Accessibility Audit Report

Institute of Home Economics

University of Delhi

1.07.2026

Entry to central courtyard

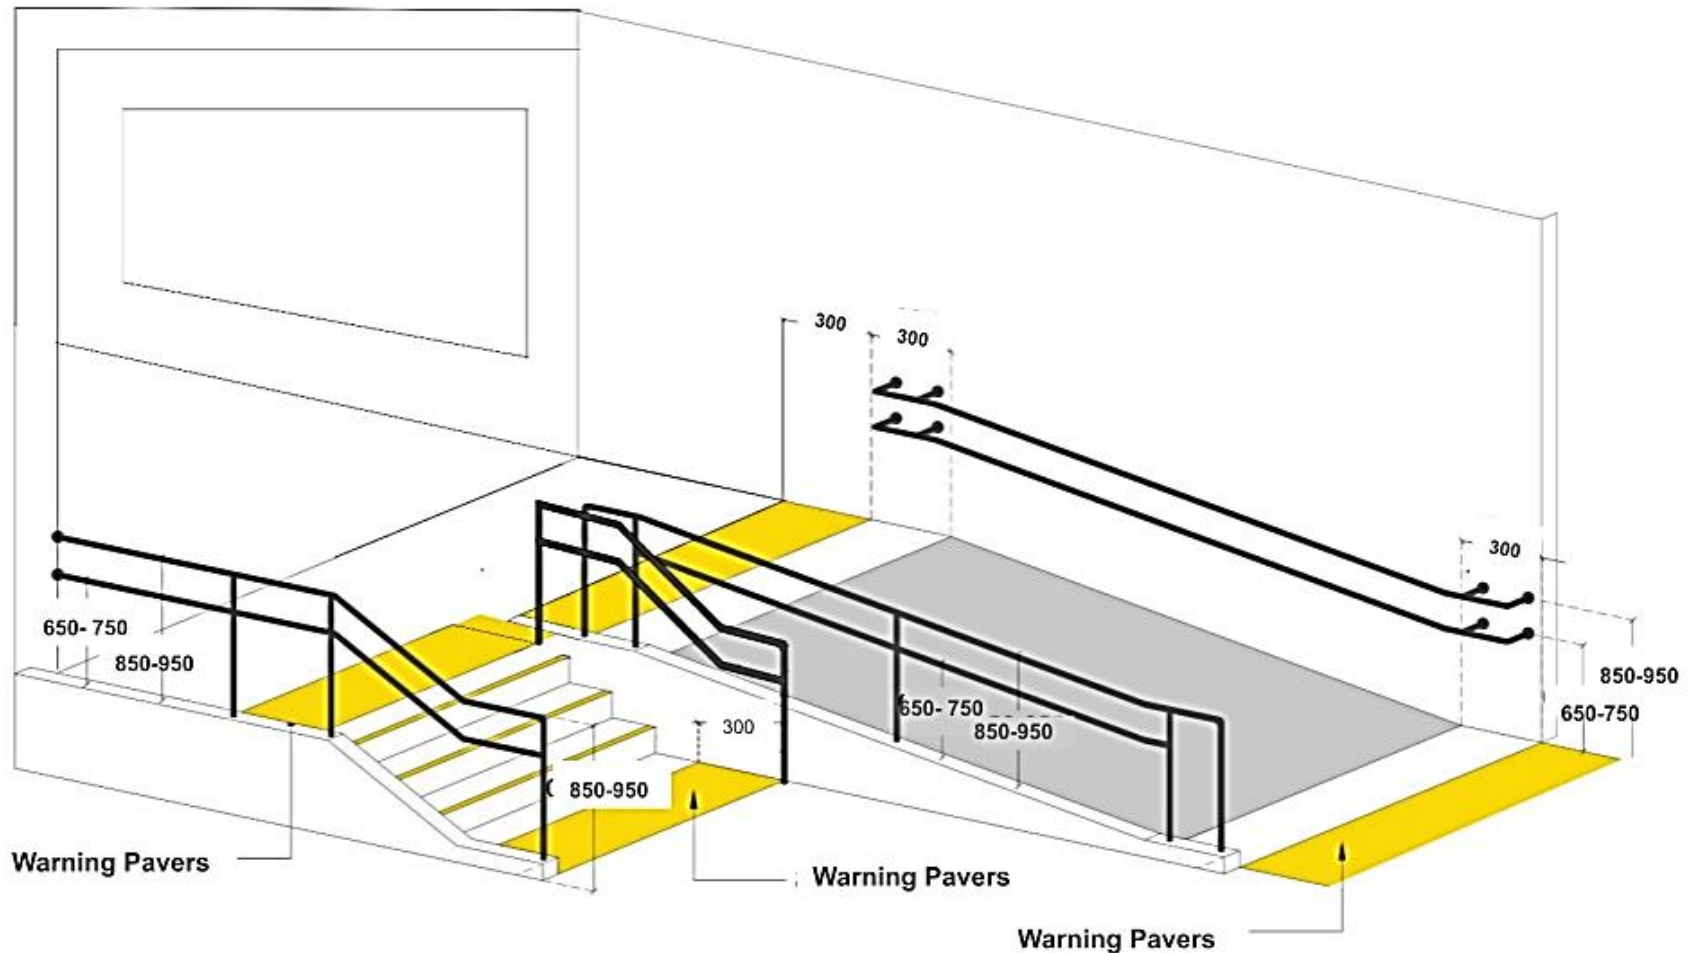
- Central courtyard is connected with 2 ramps. The length of the ramp is 2100mm and width is 900mm. Level difference is -140mm.
- One of the ramp is blocked by provision of seating.
- TGSi warning at the start and end of the ramp is missing.

Attendance – Biometric machine

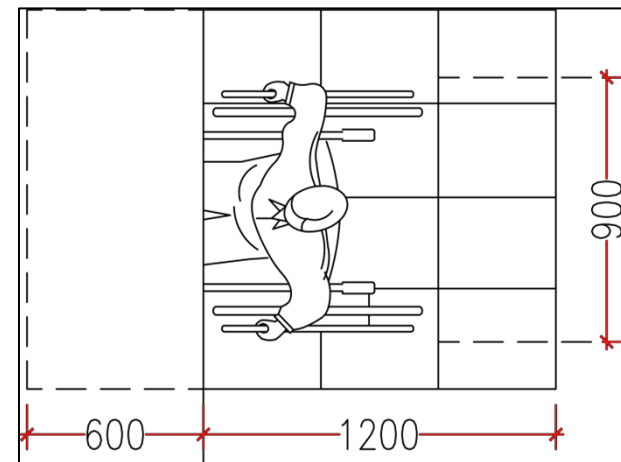
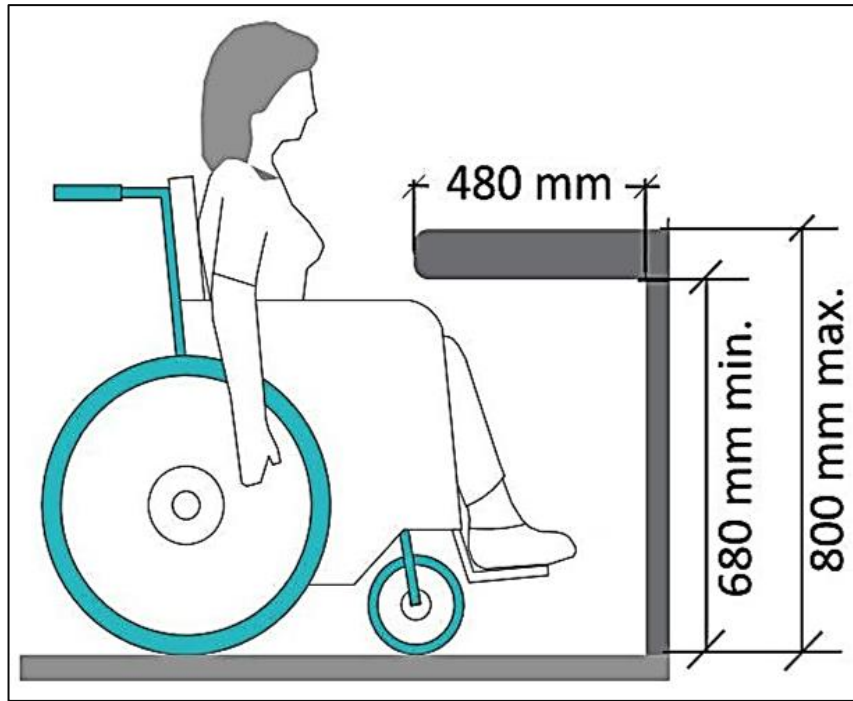
- Height of the biometric machine is 1210mm.

Entry to Admin office space, Directors room and pantry

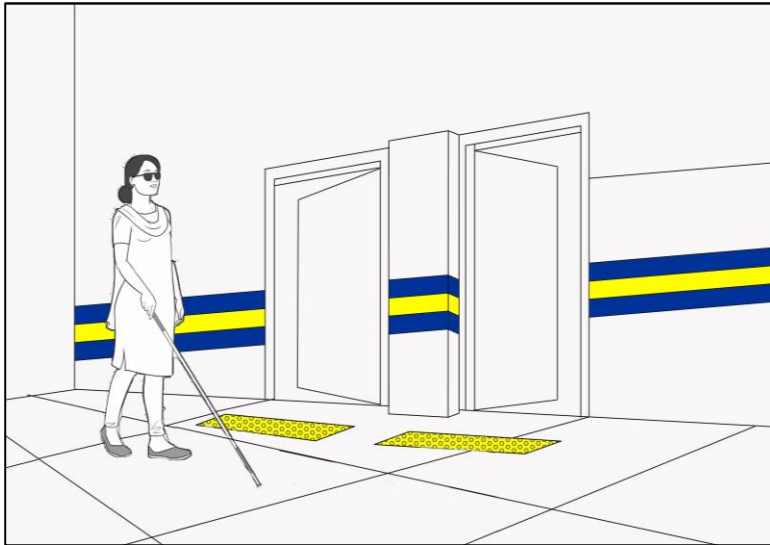
- Bevelled edges shall be provided to have smooth transition from corridor space to the office space and other adjacent rooms (Directors room, pantry) .

Lift

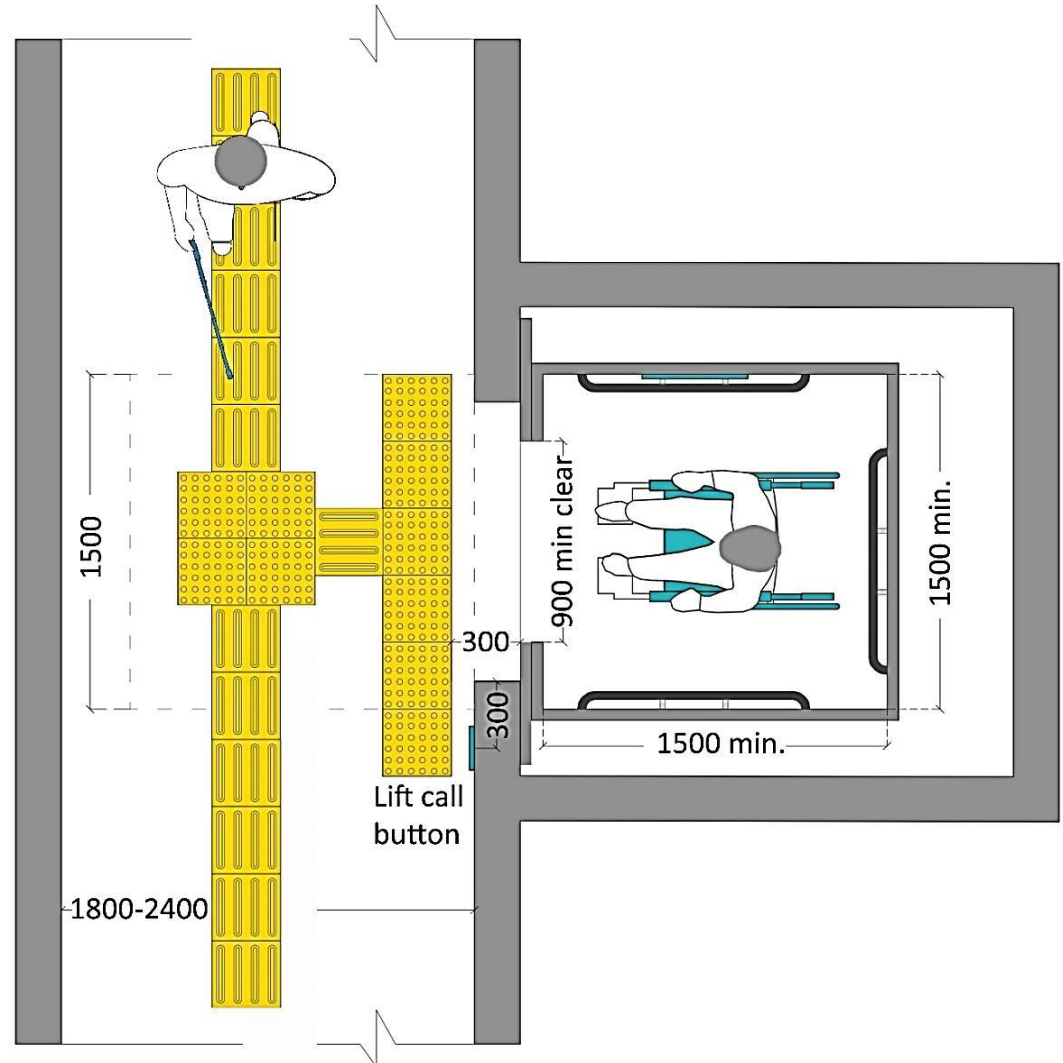
- TGSi warning is missing in front of the lift door opening.
- Size of the lift is 1590mm x 1504mm.
- Switch button is at the height of 966mm.
- Braille signage is not integrated onto the control panels. Also, the audio communication system/audible announcement status needs verification or repair.
- Height of the control panel is at 1012mm from the finish finished lift car floor level.
- Handrails at either side of the lift car is not provided. Mirror is fixed in the opposite side of the door.
- Signage for every floor level opposite to the lift is missing.

Staircase (connecting A block and B block)

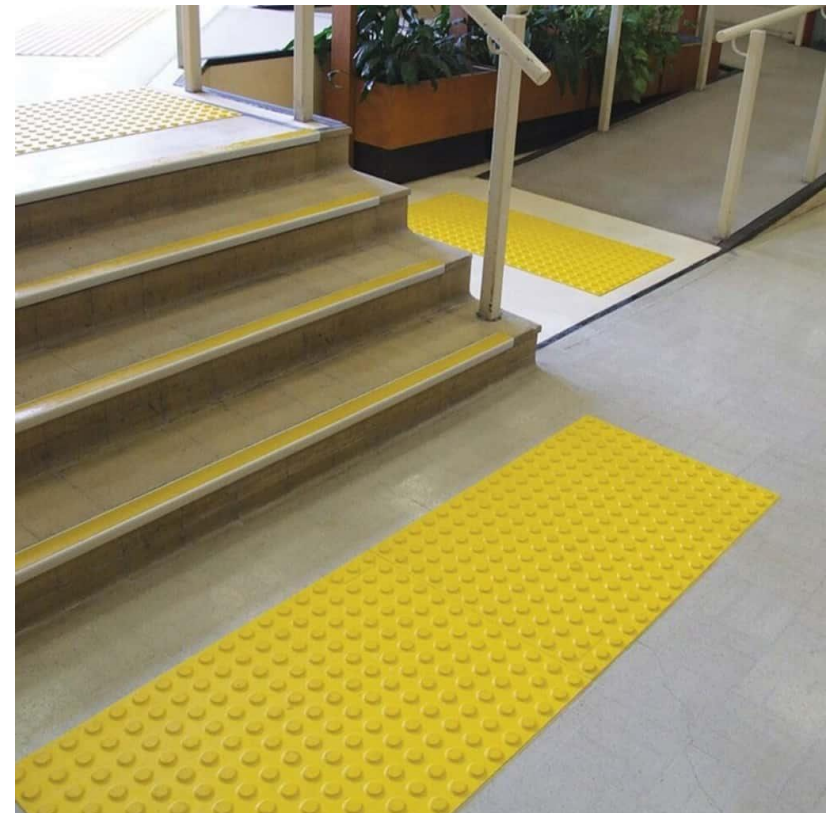
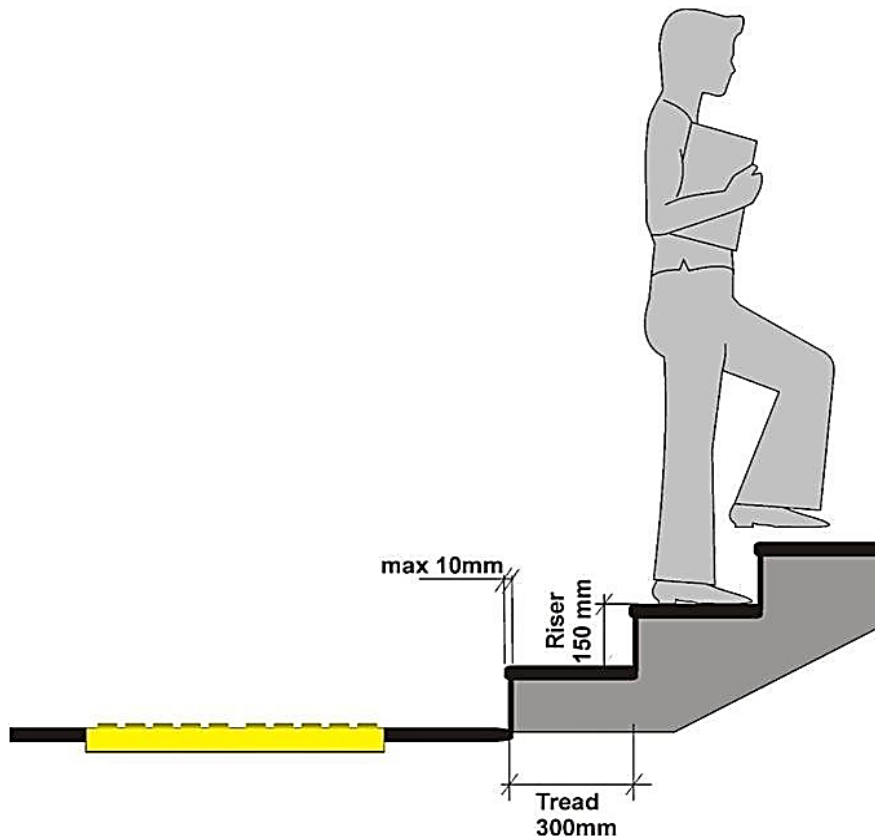
- TGSi warning is missing in the start and end of the steps including landing of the staircase.
- Handrail is missing on one side of the staircase.
- Extension of handrail on the other side to reach for person with mobility issues from the corridor level with an extension of 300mm is missing.
- Width of the step is 1360mm, height of the handrail on one side is 905mm. First step riser height is 106mm.
- Antiskid edges for each step is missing.
- This is the only access to connect B block in upper floors.
- There is no lift provision in B Block.

Transitional space in between the corridors

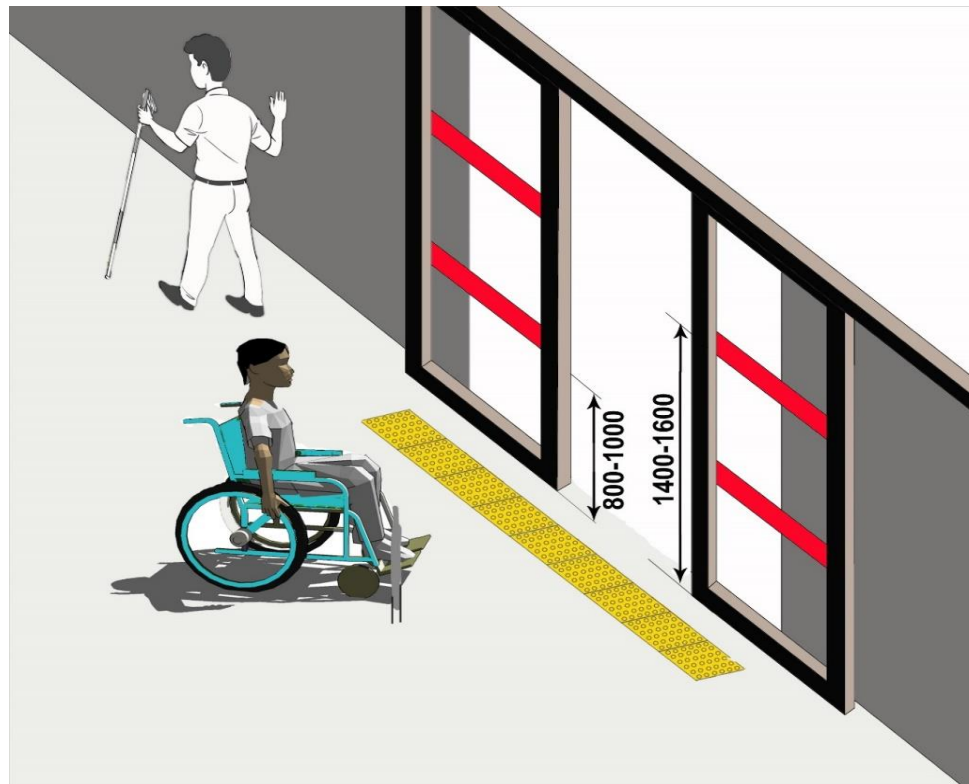
- Doors use heavy glass panels with tight clear openings (720 mm).
- People with low vision will face difficulty whenever they move in this space due to plain glass.
- This space may be created as students common room at every floor level for their discussion.

Corridor and exit connecting outdoor play area

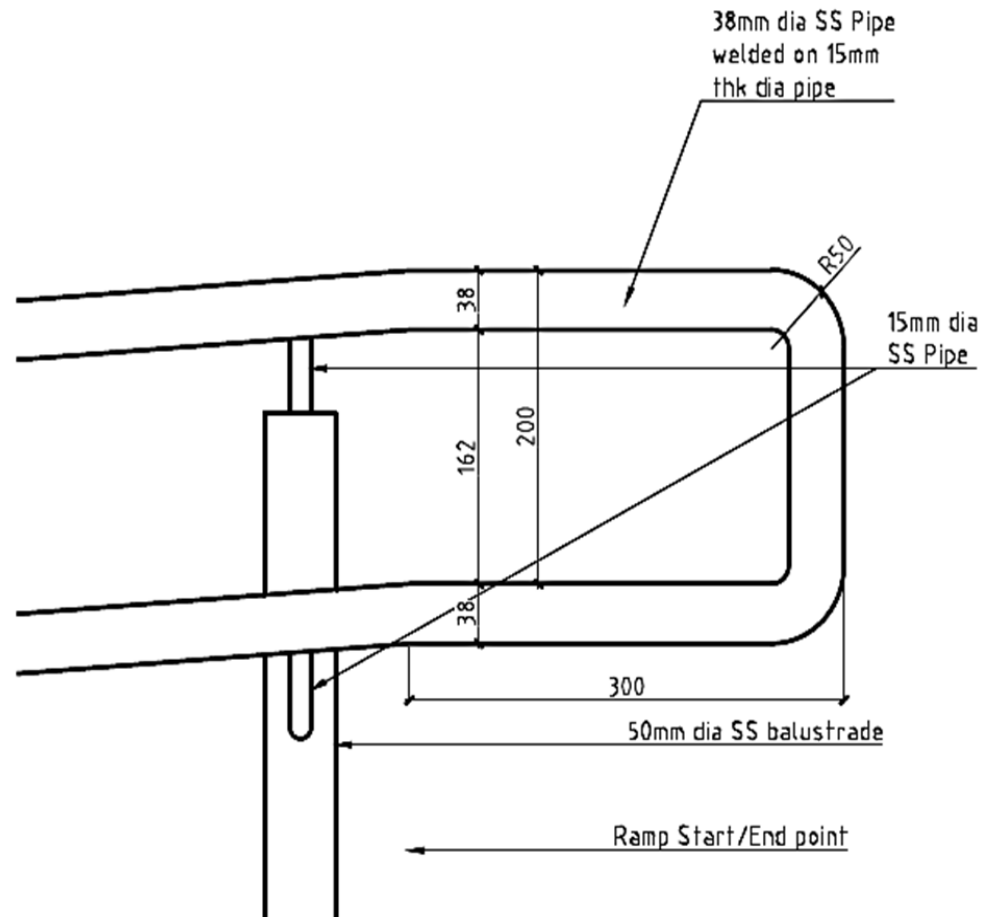
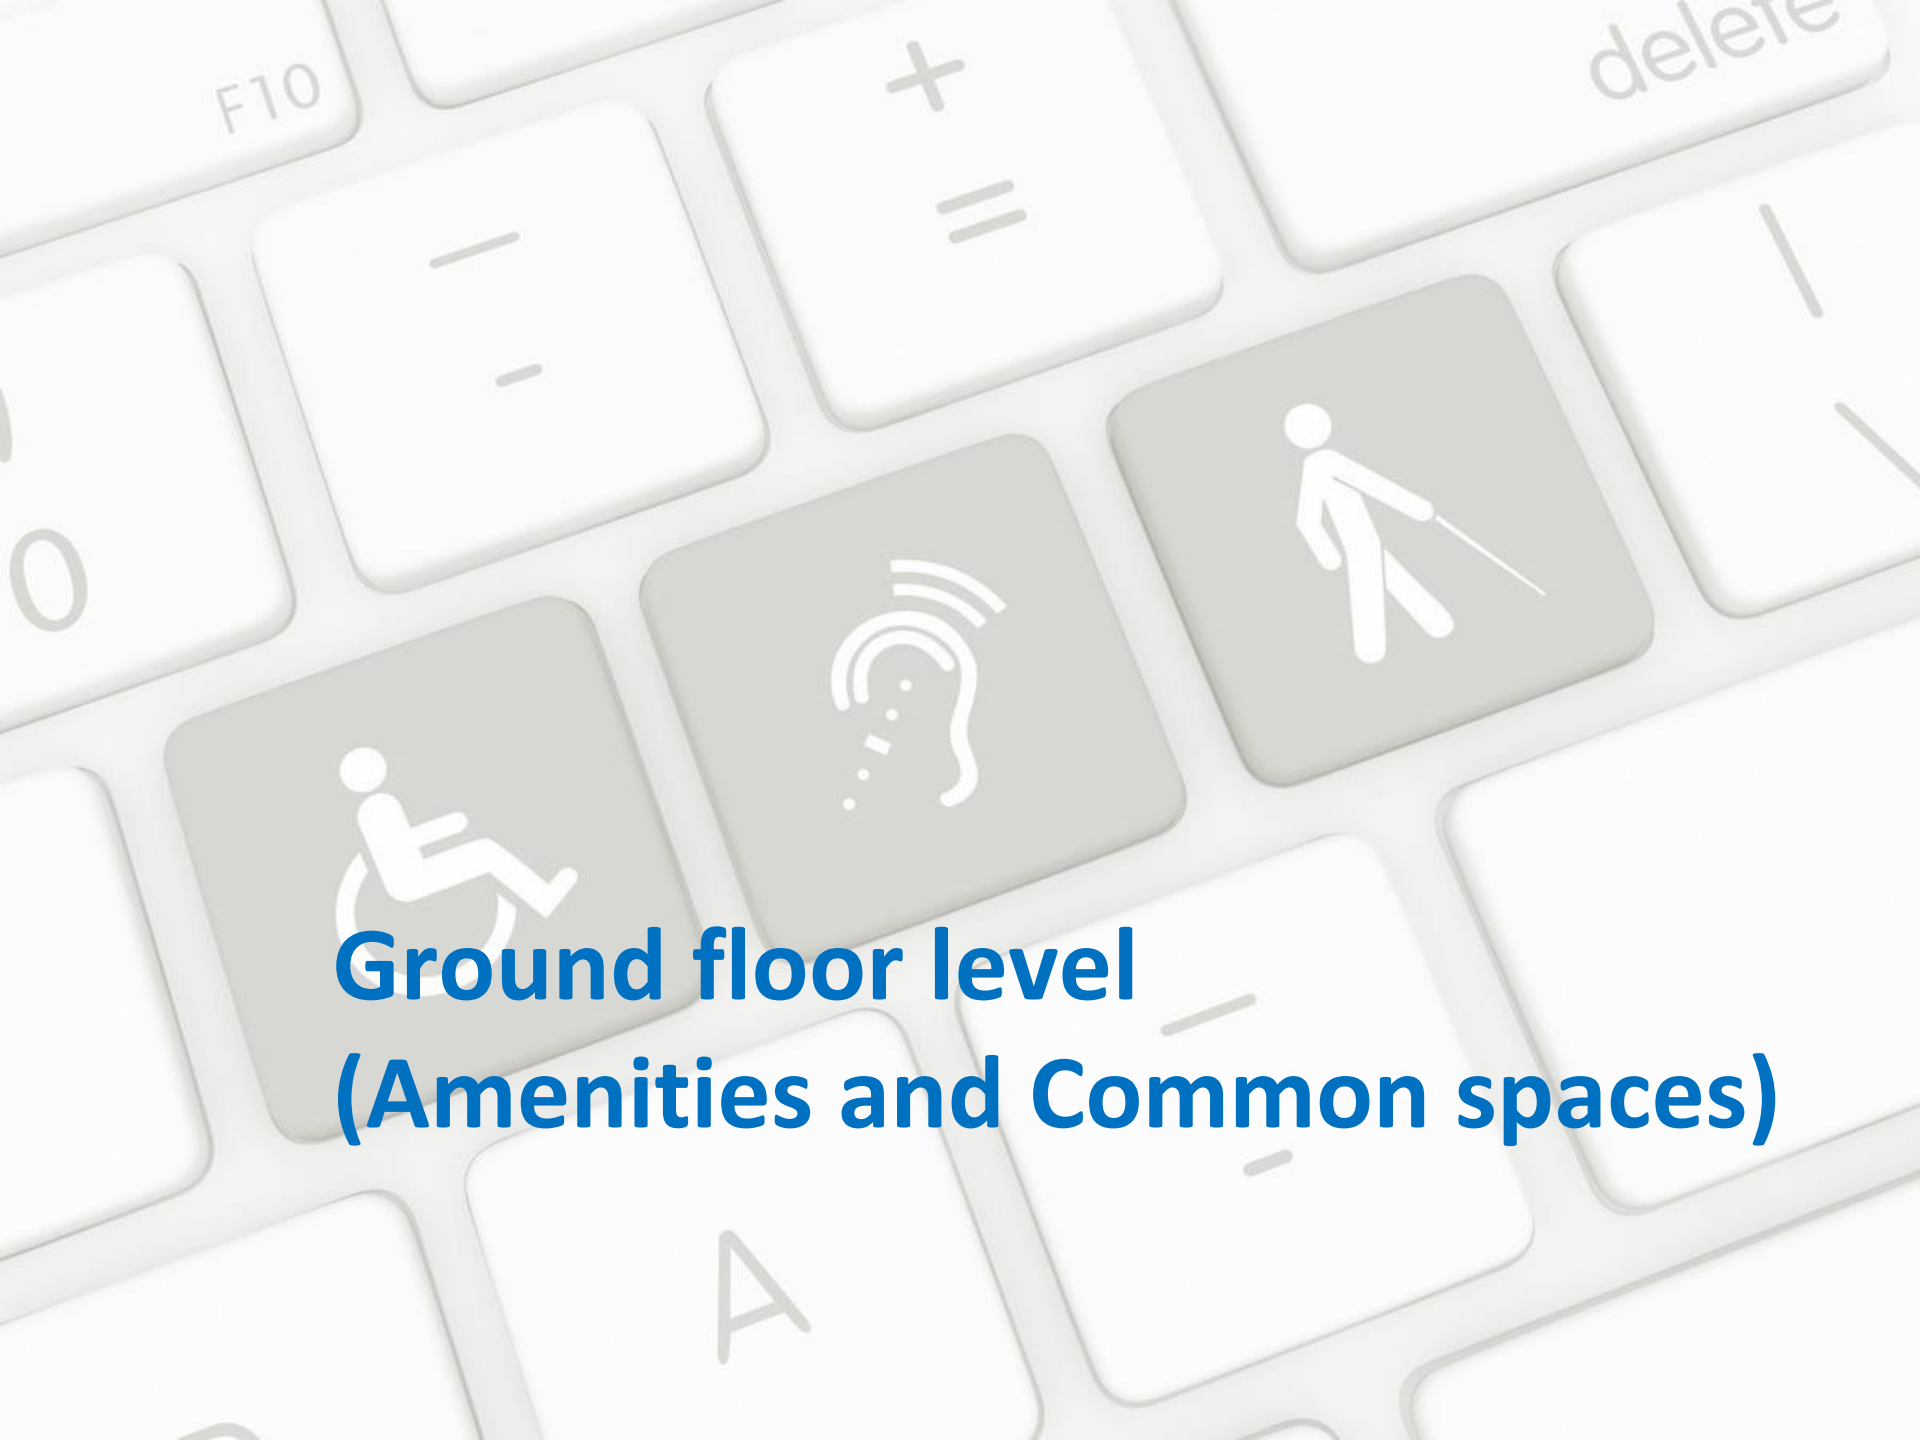
- TGSi warning is missing in the start and end of the step. including landing of the staircase.
- Level difference between the connecting corridor and the basket ball court is 170mm.
- Length of the transition space is 5968mm.
- Width between the wall and the raised platform of the basket ball court is 990mm.
- Ramp shall be provided in the direction indicated in the photo below.

Water Dispenser

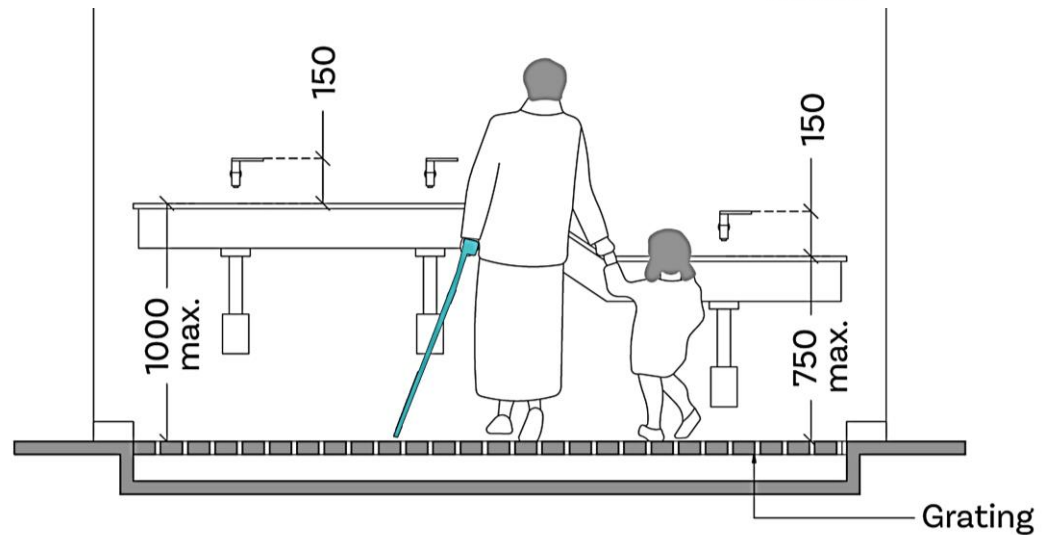
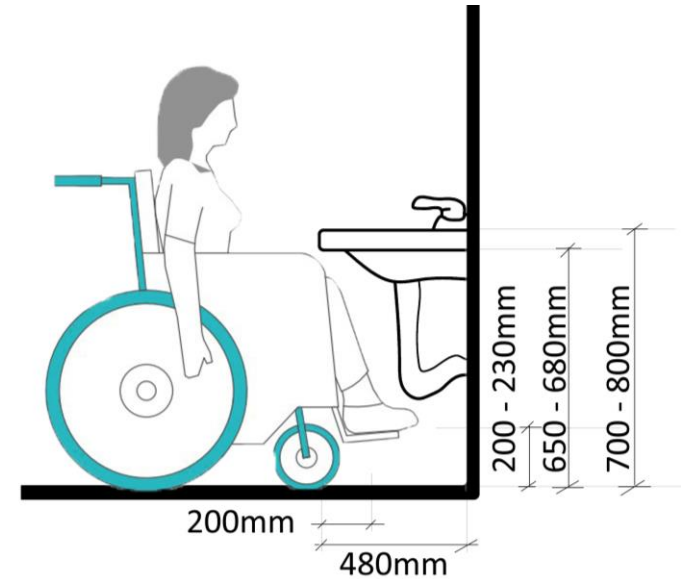
- Taps are high and not accessible.
- **Provide taps at two levels so that dwarf women and those using wheelchair can also access the drinking water unit.**
